PROJECT: Quest Academy

SUBMITTAL: 3rd

CITY OF LAS VEGAS		DATE:
INTER-OFFICE MEMORANDUM		November 1, 2012
TO: Land Development Services Department of Public Works		FROM: Albert Sung, P.E. Flood Control Project Engineer Department of Public Works
SUBJECT: Drainage Study for: Quest Academy		COPIES TO: DRC Surveying Nevada, Inc.
Cross Streets:	SWC Deer Springs Way & Grand Canyon Dr	Quest Academy
File Number:	F:\Depot\DSMemos\DS4572C.doc	Bart Anderson, P.E., DevCo
Parcel Number:	125-19-301-007 & 125-19-301-008	CCPW
Zoning Action:	SDR-46570; SUP-46572; SUP-46573 & PMP-46996	
FEMA Flood Zone	YES NO X	
Proposed Storm Drain	YES X NO

FIGURE 11
QUEST ACADEMY
STREET FLOW SECTION MAP

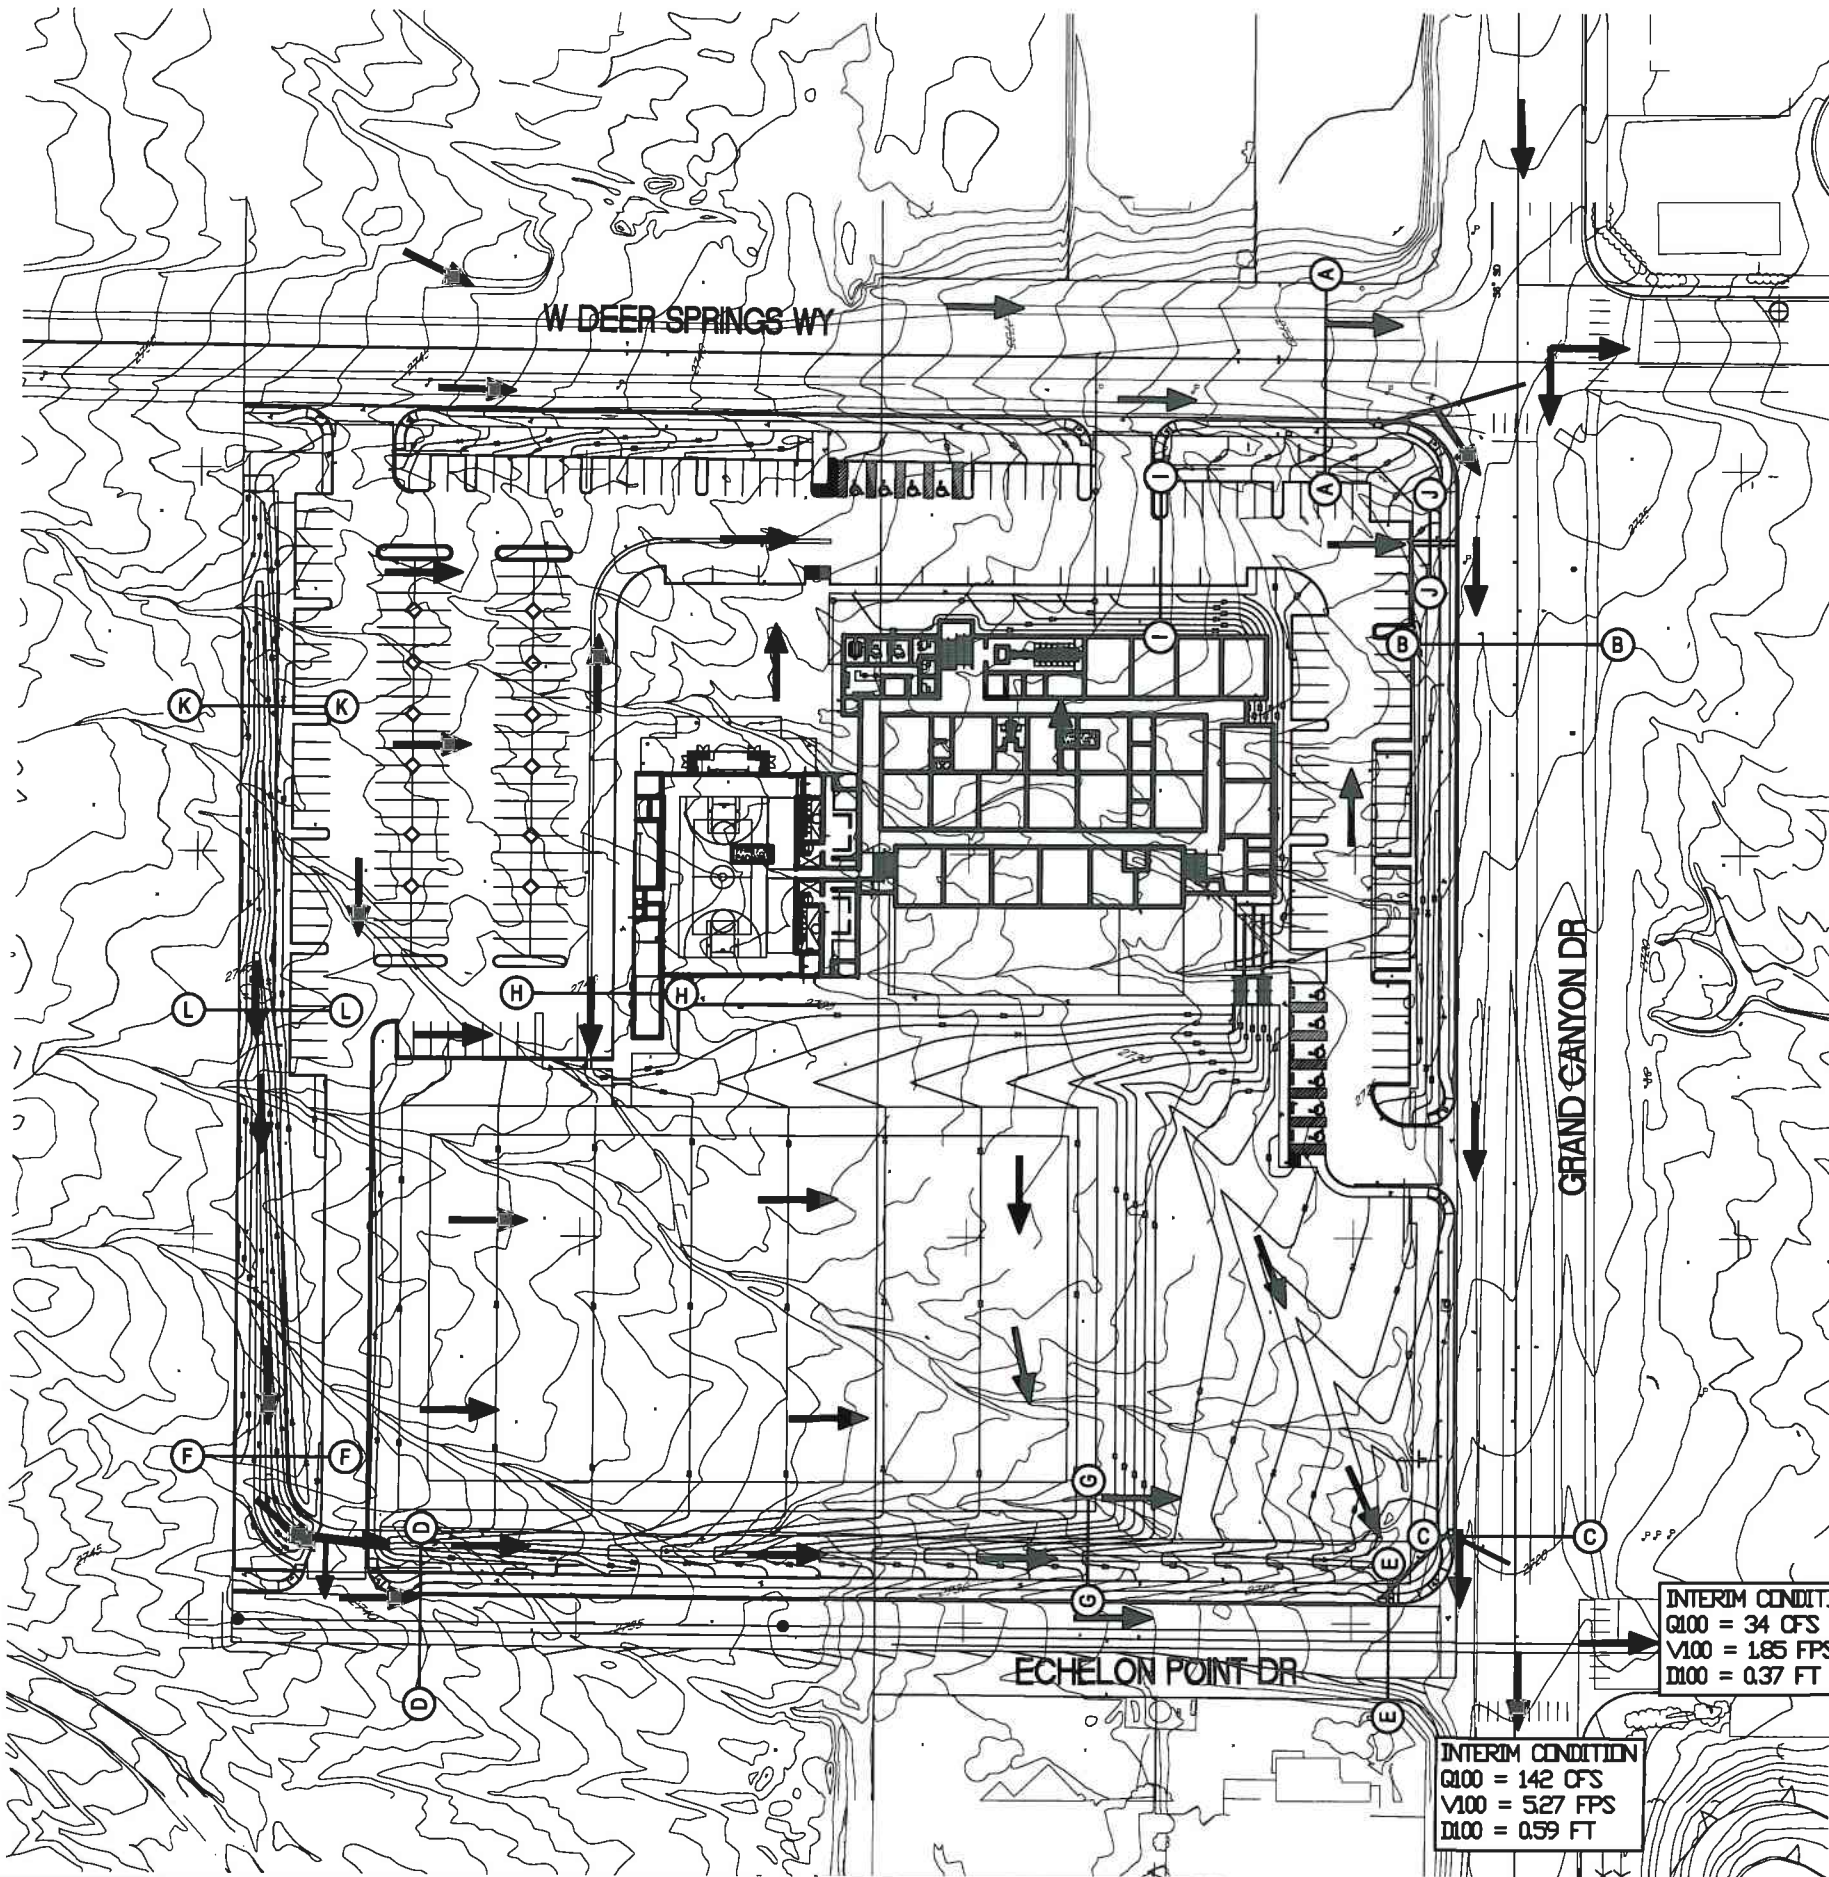
4. **The Interim and Existing Condition Drainage Maps cited a 100-year of 136cfs at “CP-4D” (intersection of Deer Springs Way and Grand Canyon Drive) from reference study. A flow split result was stated that 49cfs would drain east in Deer Springs Way and 111cfs would drain south in Grand Canyon Drive. However, a flow split calculation was not found in the technical drainage study. Provide as such in the next submittal and revise all subsequent calculations necessary.**

The section of the riprap channel was revised as requested. The minimum depth of the channel has been added. Two more normal depth calculations were performed within the channel along the west boundary. Some riprap on the upper end of the swale was removed since the velocities are less than 5 fps. Figure 11 was revised accordingly.

SHEET 3 OF 12
DRAWING NO.

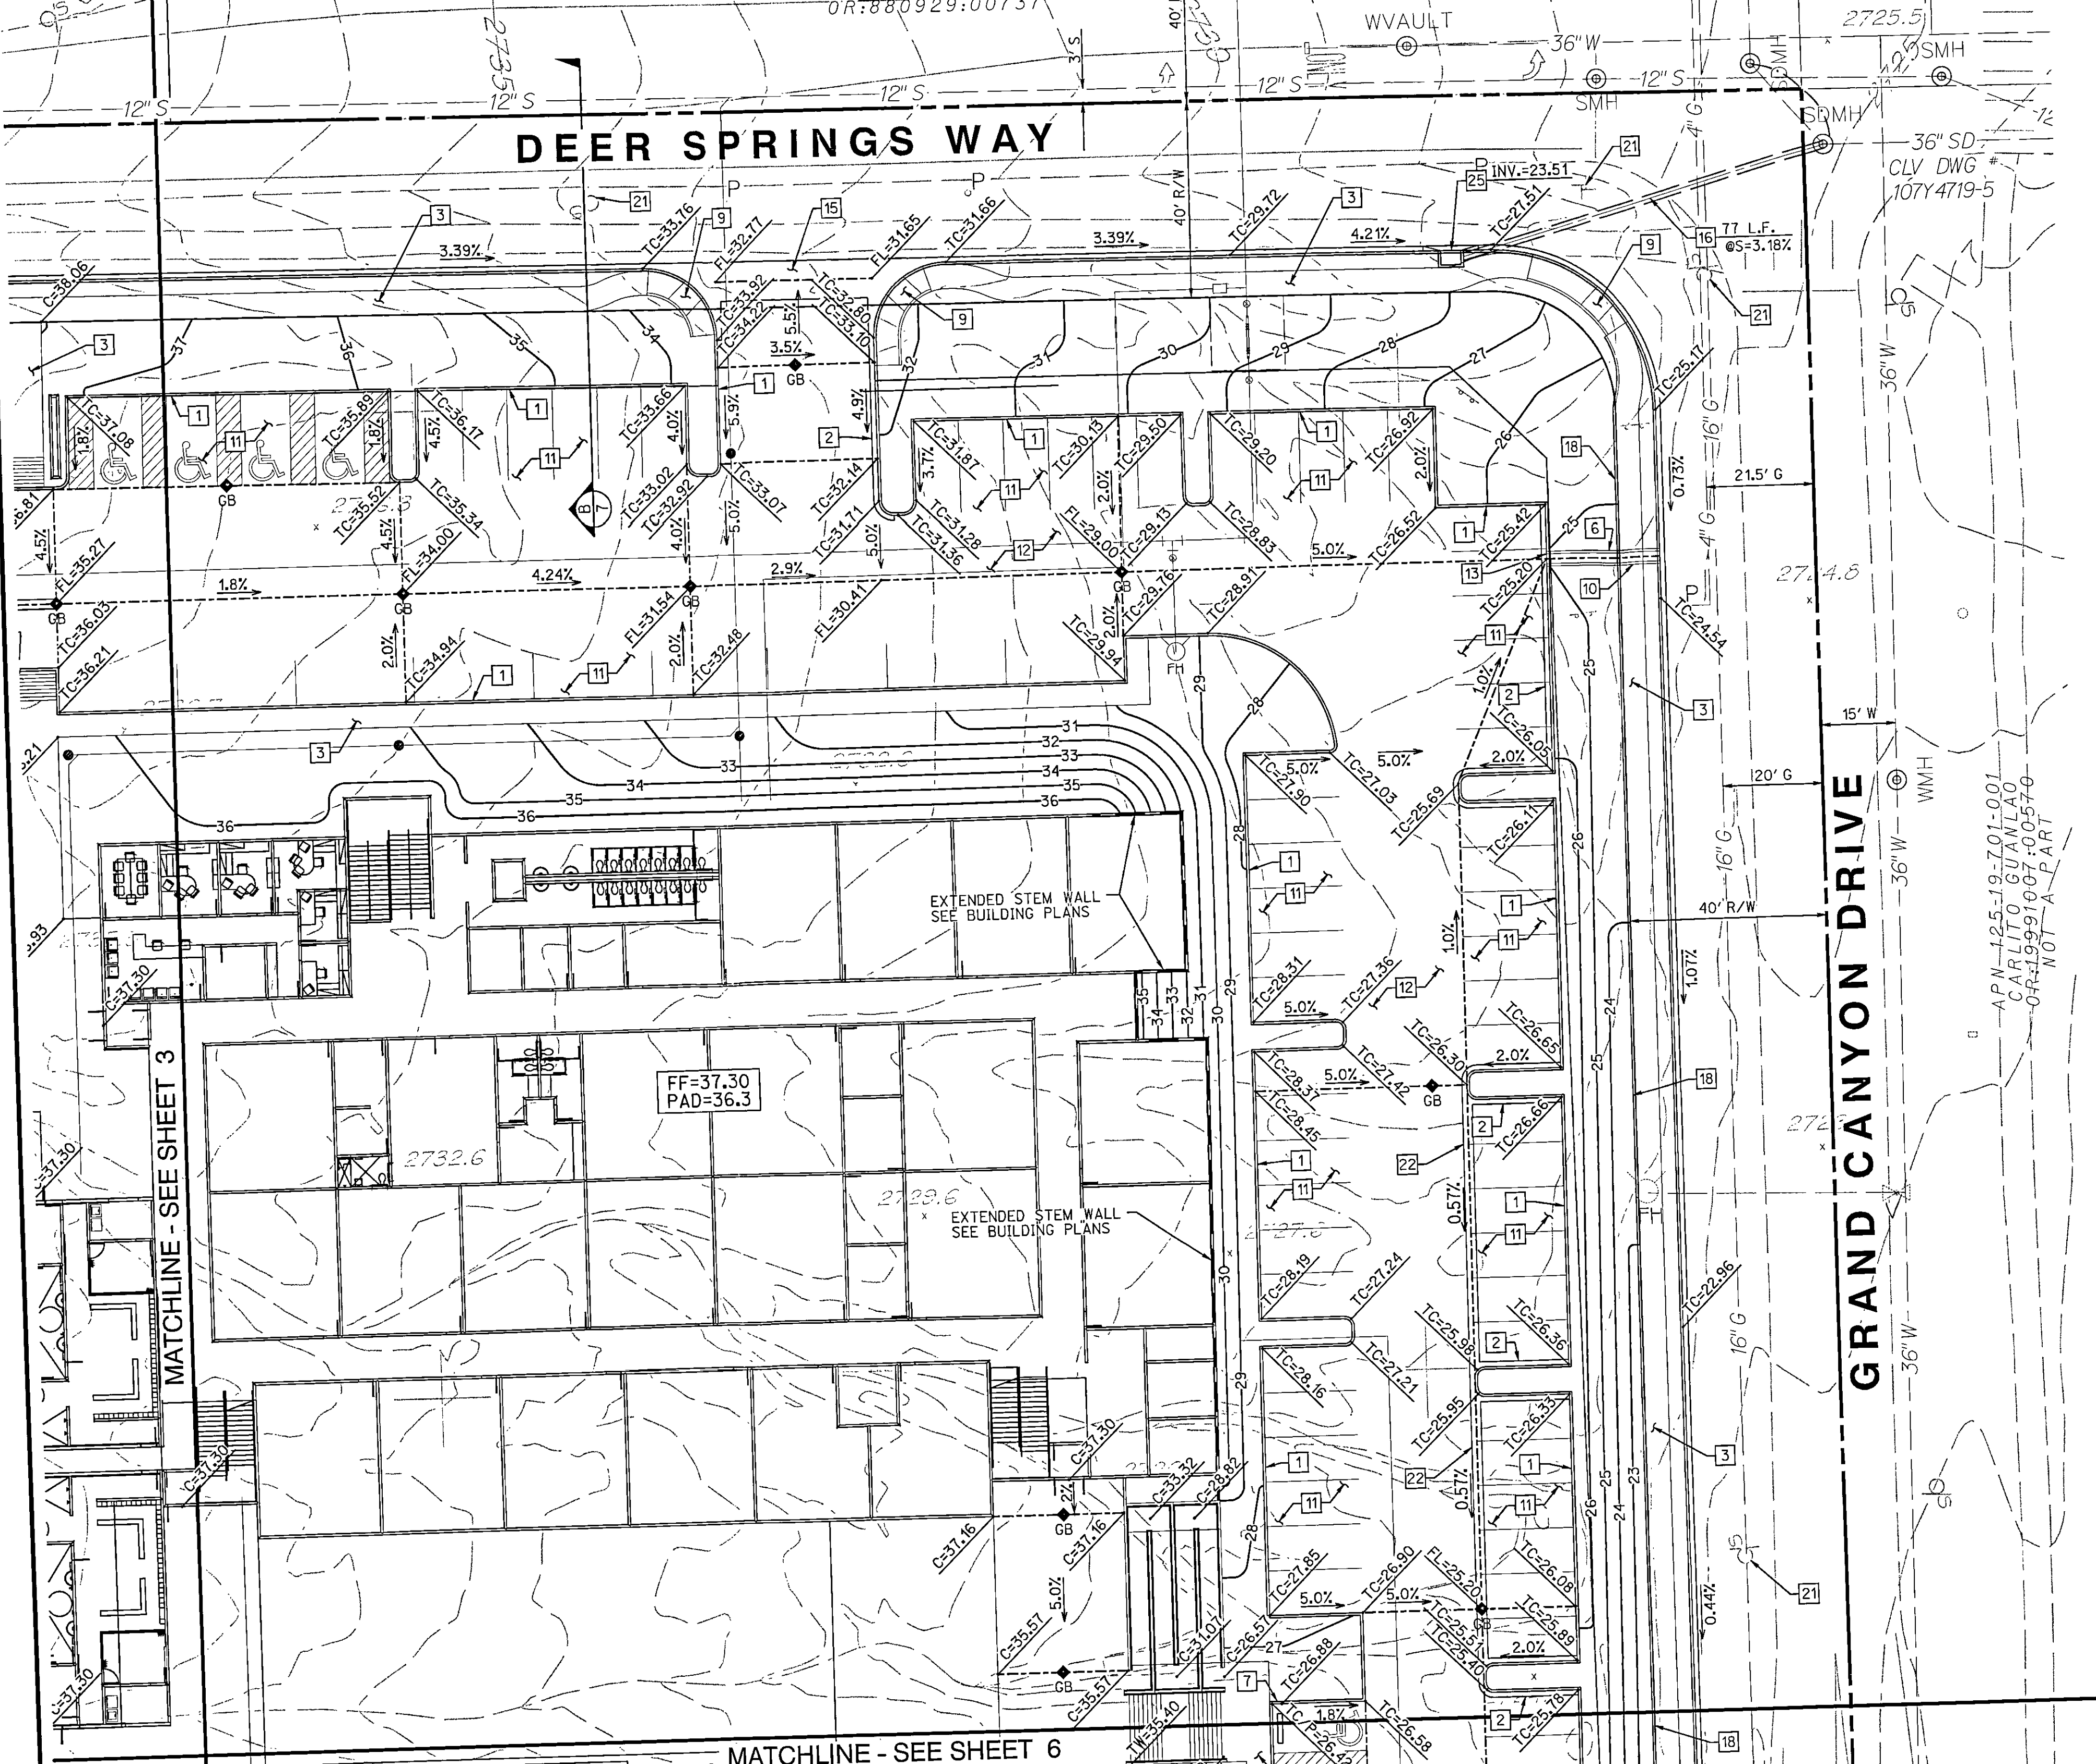
5. **On Sheet 3 of 12 (Grading Plan), a $Q_{10}=5\text{cfs}$ and $Q_{100}=24\text{cfs}$ were labeled in Deer Springs Way. However, when comparing the flow rates to the Depth Flow Summary Table in Figure 11 (Street Flow Section Map) of the drainage study, discrepancies occur at Section A-A of “Int. Deer Springs” and “Ult. Deer Springs”. The situation also holds true in the proposed riprap channel and elsewhere. Review and revise accordingly.**

6. **Sheet 3 of 12 (Grading Plan):** The plan shows a flow line of 0.5% adjacent to the west and north sides of the proposed building in asphaltic pavement. Note that 0.5% in asphalt does not drain well. Provide a minimum of 2'-concrete valley gutter in place where slope is less than 1%. Review and revise accordingly.

The flow rates were taken off the grading plans since all the information is provided on the drainage maps within the study. Having flows on the grading plans would create confusion because there are multiple conditions. To be meaningful, the flow quantities need the context of the study.

Sheet 3 was revised to include a 2-ft wide concrete valley gutter at swales less than 1% slope.
